**RE-NOTIFICATION OF UNREMEDIED SAFETY
DEFECT ON YOUR BLUE BIRD BUSES**

**SUBJECT: RECALL R13WD GRID HEATER POWER CABLE MAY CONTACT
FRAME RAIL**

Grid Heater Power Cable May Contact Frame Rail

CORRECTIVE ACTION

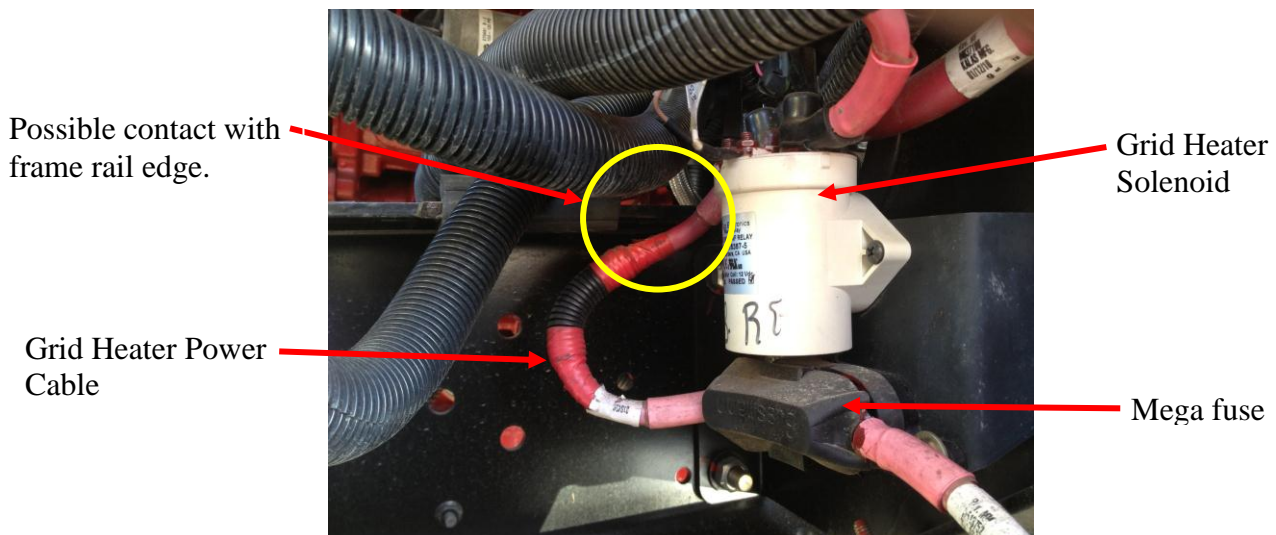
The grid heater power cable may be improperly routed which could result in contact with the chassis frame rail. If the cable contacts the chassis frame rail it could potentially chafe against the frame thereby creating a short which could result in a fire.

Inspect for proper positioning of the grid heater power cable. If any grid heater power cable is contacting the frame rail, remove and inspect. If there is any damage, replace cable and install per instructions below. If there is no damage, reinstall per instructions below.

ILLUSTRATION 1

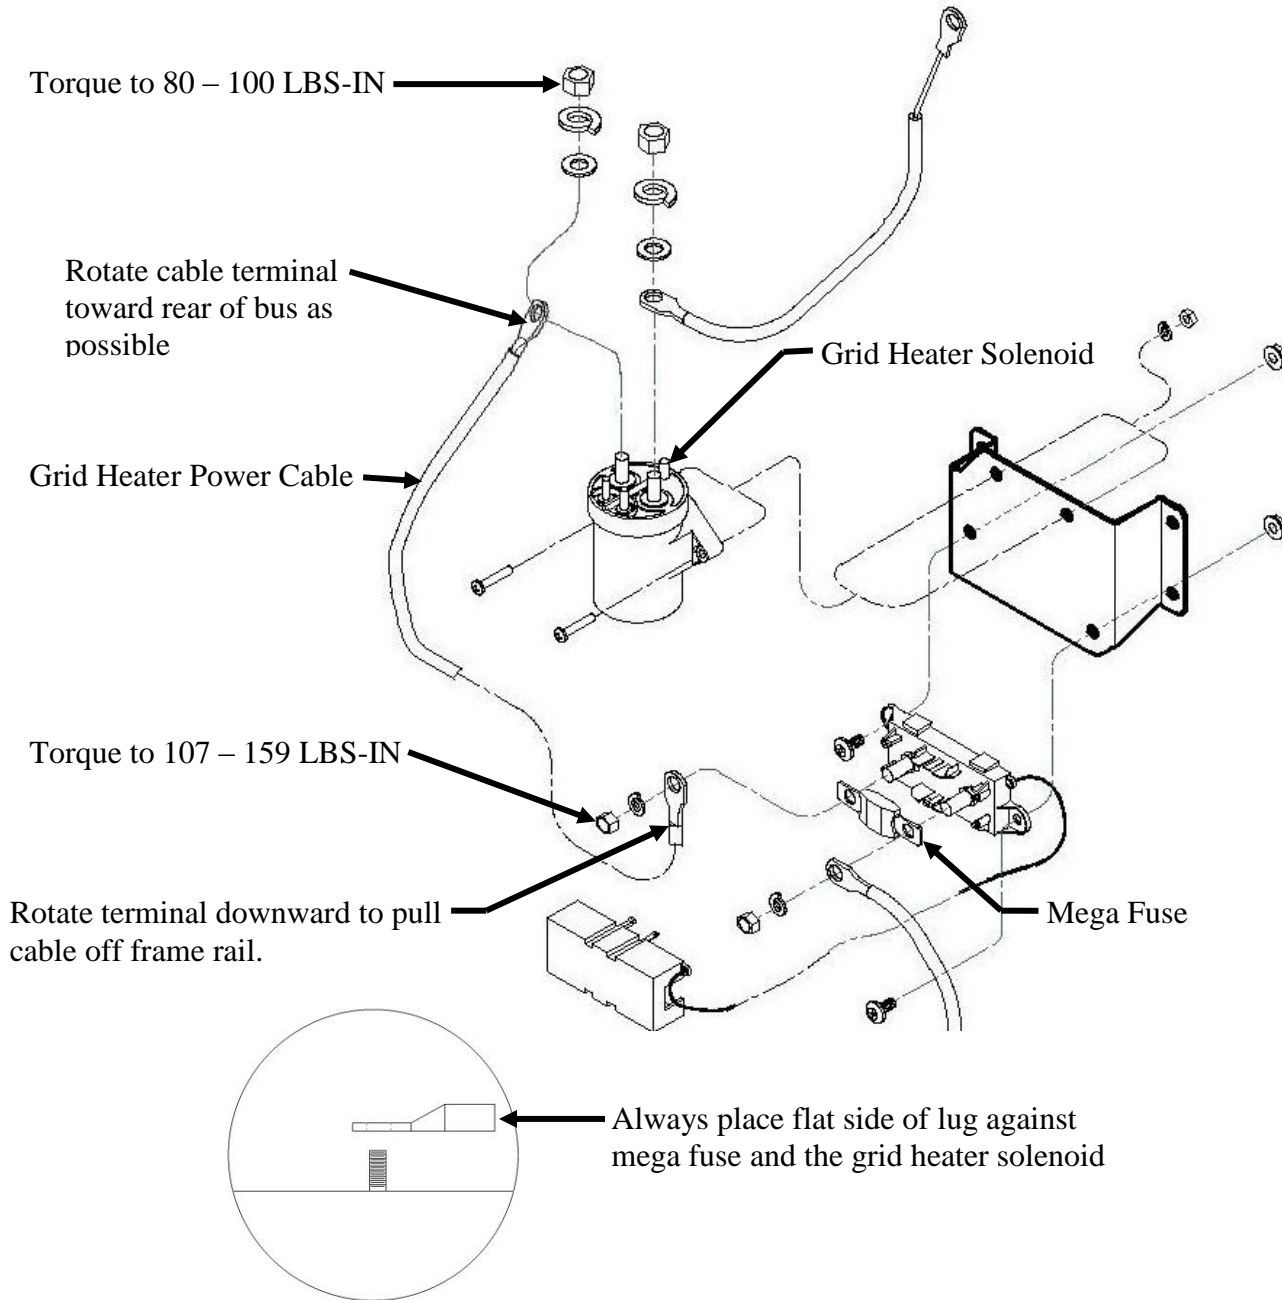
- 4. **If the grid heater power cable is contacting the frame rail edge:**
 - a. Disconnect the battery cables by removing the negative cable first and then the positive.
 - b. Remove the grid heater power cable and inspect for any damage to the cable. If no damage, reinstall per Illustration 1 on page 3. If there is any damage, contact Blue Bird Recall Administrator for replacement cable, replace cable and install per Illustration 1 on page 3.
 - c. Reconnect the battery cables, positive first and then negative.
 - d. Place bus back in service.

- 5. **If the grid heater power cable is not contacting the frame rail edge but is close to the frame rail edge,** the cable must be repositioned to provide maximum clearance to frame rail. Do not bend the cable away from the frame rail, it **MUST** be repositioned:
 - a. Disconnect the battery cables by removing the negative cable first and then the positive.
 - b. Remove the grid heater power cable and reinstall per Illustration 1 on page 3. If there is any damage, replace cable and install per Illustration 1 on page 3.
 - c. Reconnect the battery cables, positive first and then negative.
 - d. Place bus back in service.

- 6. **If the grid heater power cable is already positioned per Illustration 1 on page 3, no further action required.**
